VIRGINIA ELECTRIC AND POWER COMPANY
RICHMOND, VIRGINIA 23261

VIRGINIA ELECTRIC AND POWER COMPANY
NORTH ANNA POWER STATION UNITS 1 AND 2
RESPONSE TO REQUEST FOR ADDITIONAL INFORMATION
PROPOSED TECHNICAL SPECIFICATIONS CHANGES
REACTOR COOLANT SYSTEM PRESSURE/TEMPERATURE LIMITS
LTOPS SETPOINTS, AND LTOPS ENABLE TEMPERATURES

Attachment 1
Discussion of Change

North Anna Power Station
Units 1 and 2
Virginia Electric and Power Company
(Dominion)

Figure 3.4-2 — North Anna Unit 1
Reactor Coolant System Heatup Limitations

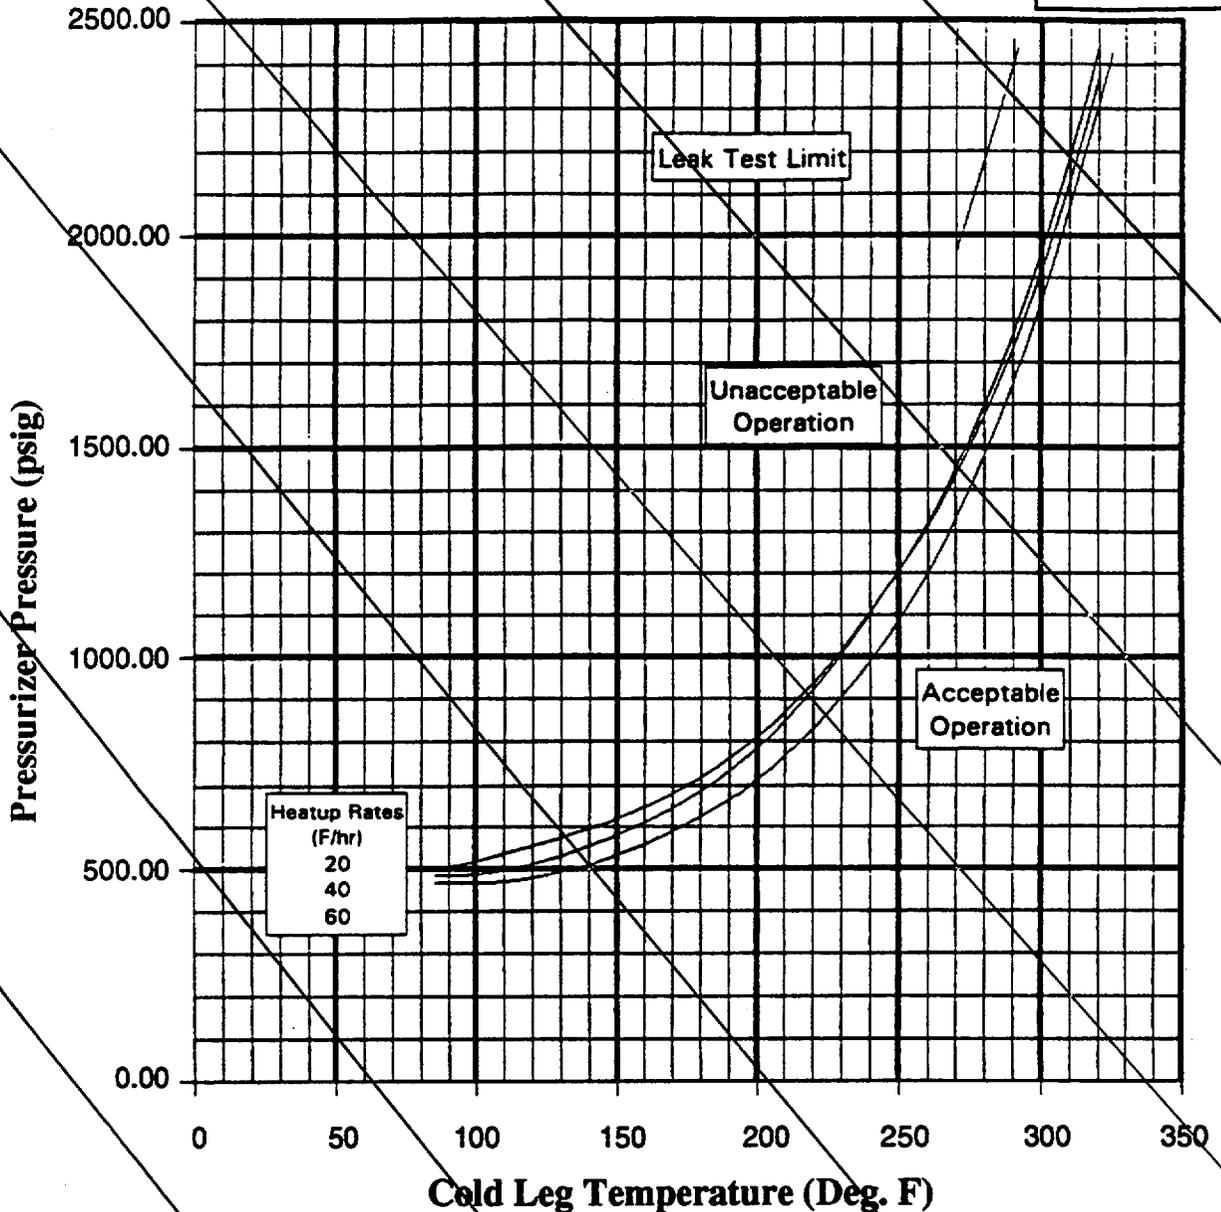
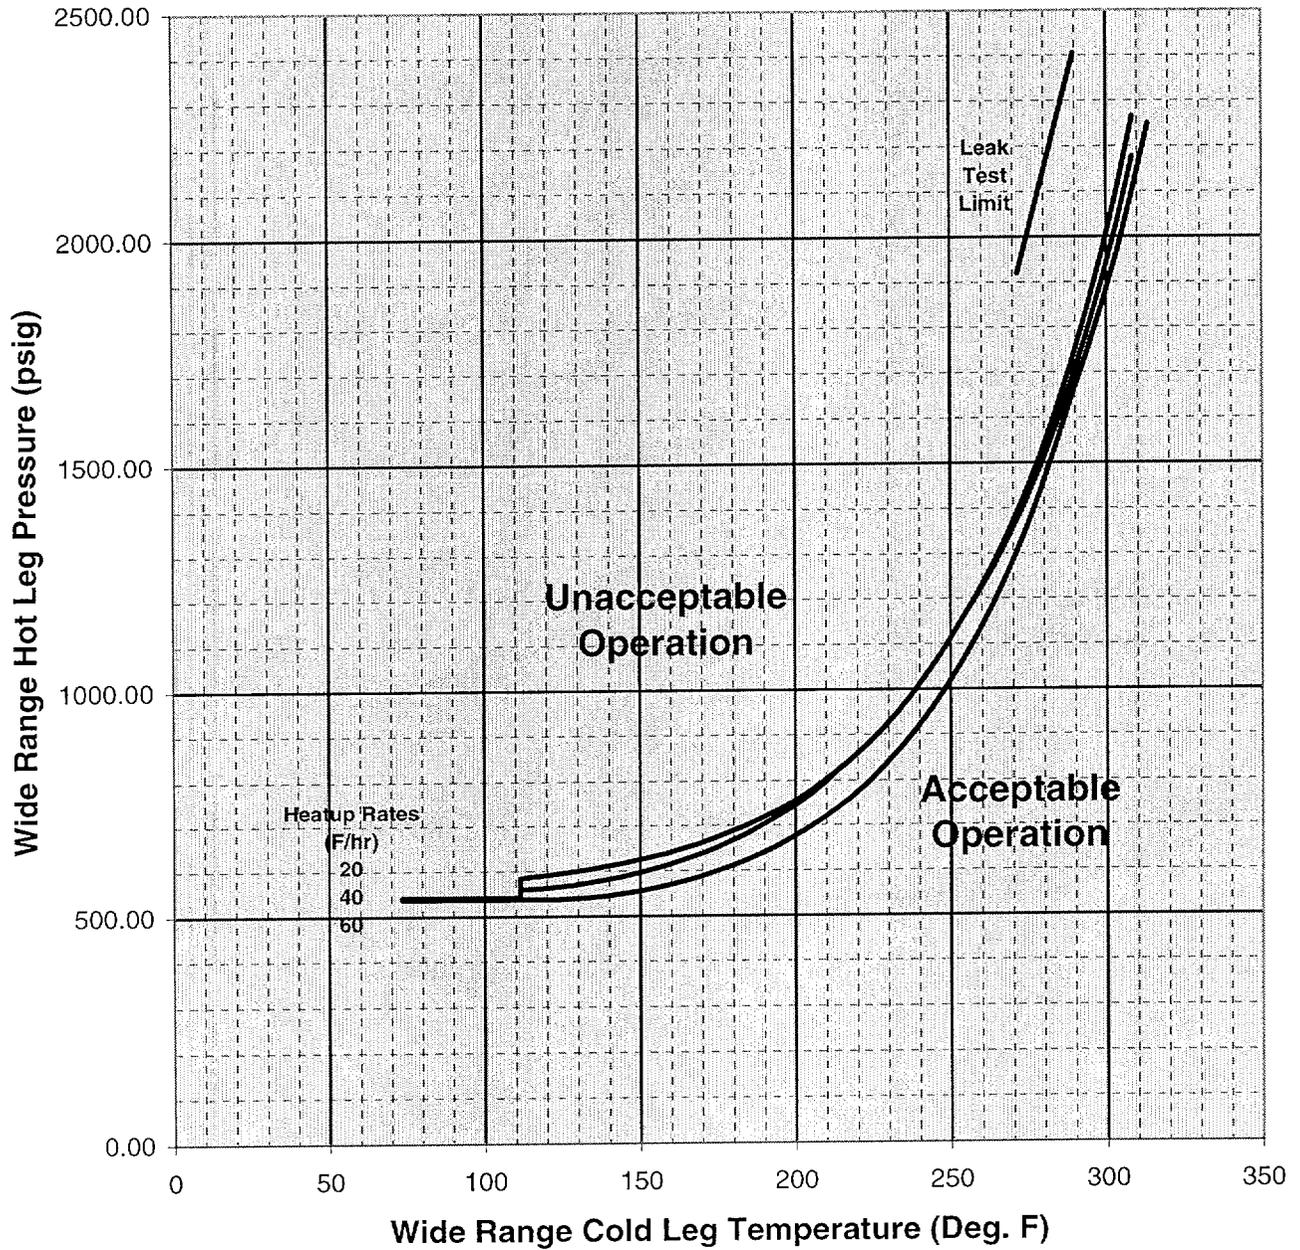
Revised North Anna Units 1 and 2 Technical Specification RCS P/T limits applicable to heatup (i.e., North Anna Units 1 and 2 Technical Specification Figures 3.4-2) were proposed in Reference [2]. The RCS P/T limits applicable to heatup presented in Appendix B replace those previously

proposed in Reference [2]. This replacement corrects the error introduced into the previously proposed curves by the computer code error described above.

Replace w/new Figure 3.4-2

North Anna Unit 1 Reactor Coolant System Heatup Limitations (Heatup Rates up to 60 F/hr)
Applicable for the first 32.3 EFPY (Including Margins for Instrumentation Errors)

Figure 3.4-2 — North Anna Unit 2
Reactor Coolant System Heatup Limitations

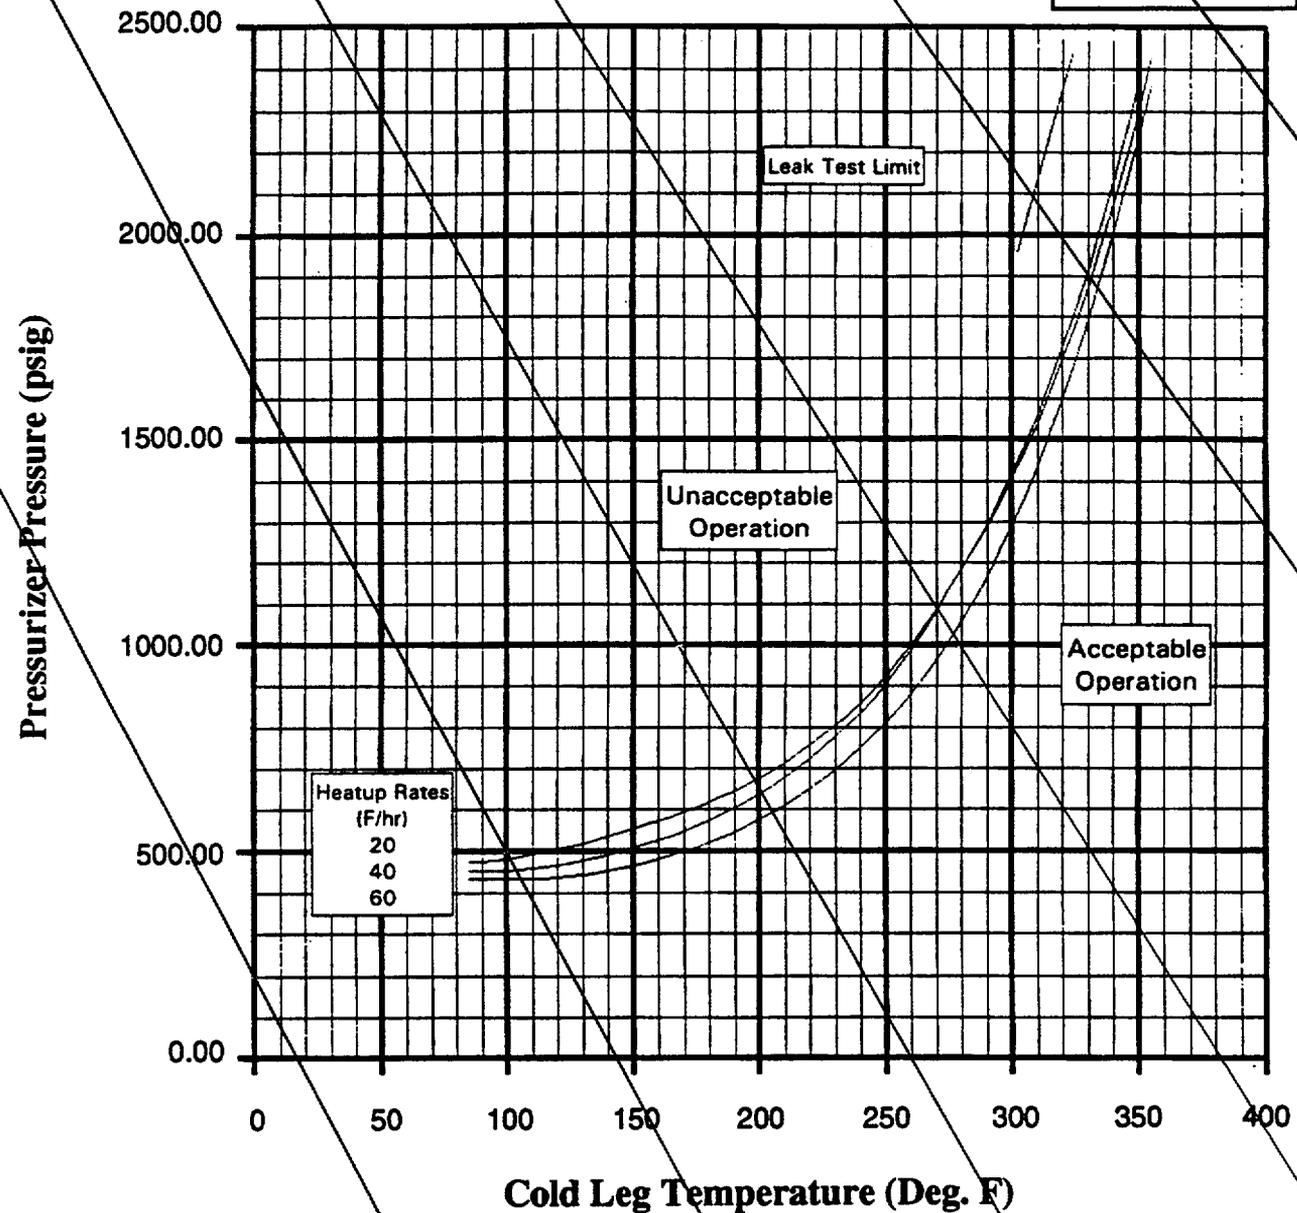
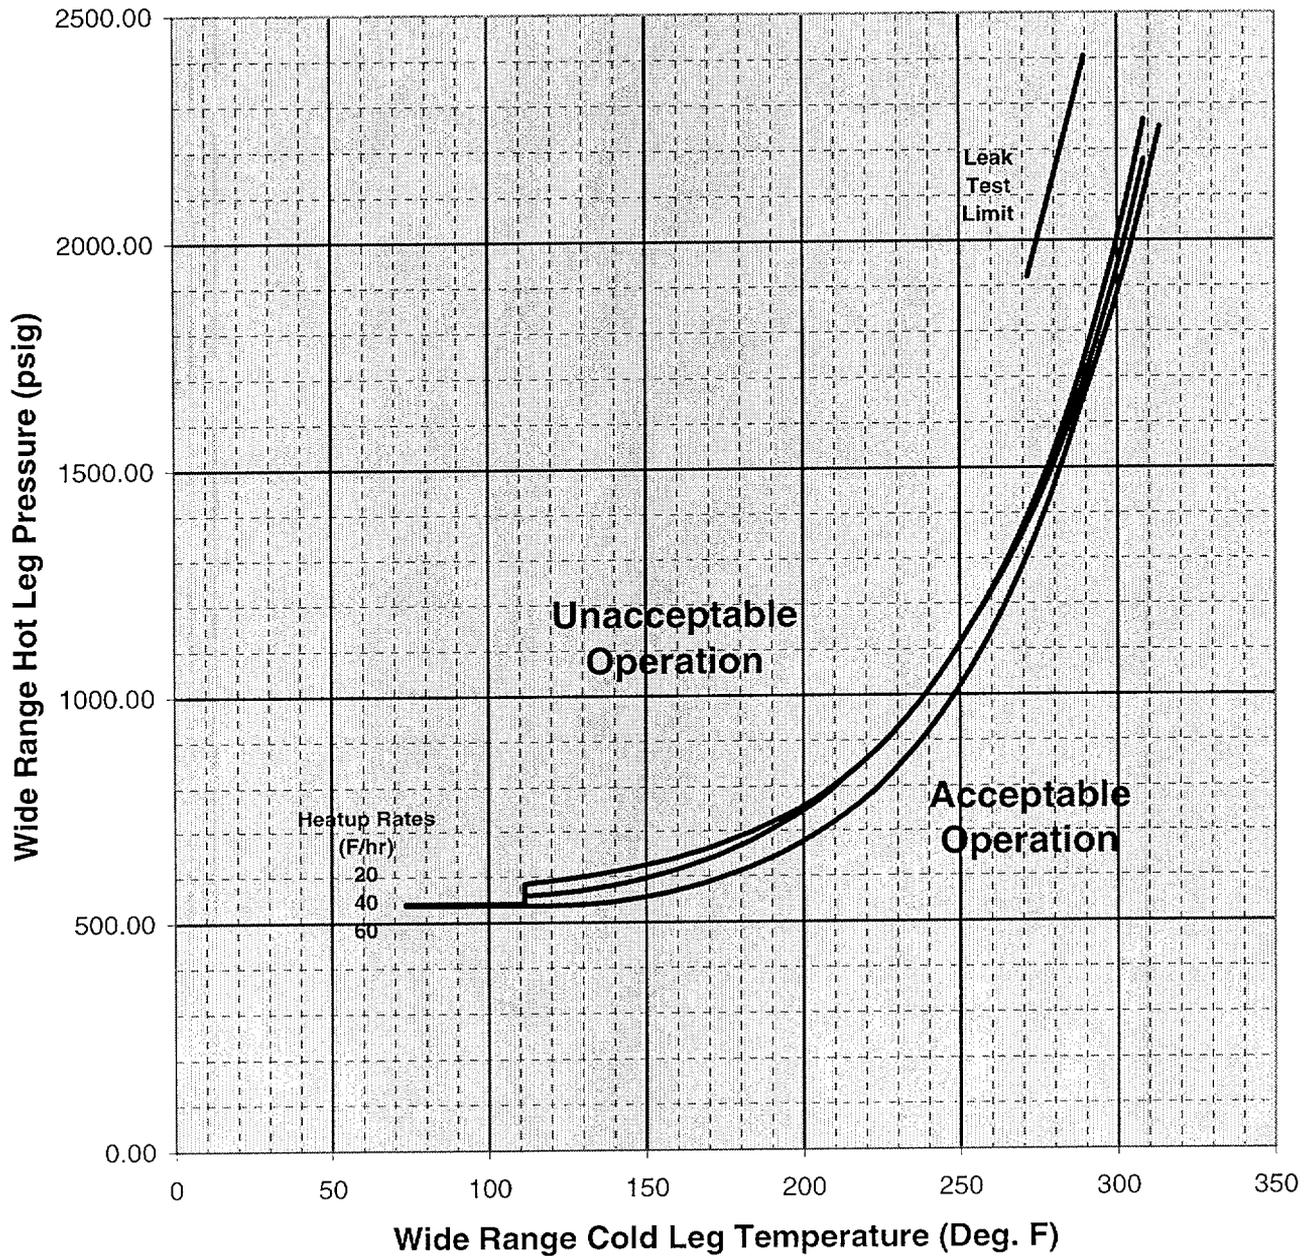
Replace w/ new Figure 3.4-2

North Anna Unit 2 Reactor Coolant System Heatup Limitations (Heatup Rates up to 60 F/hr)
Applicable for the first 34.3 EFPY (Including Margins for Instrumentation Errors)
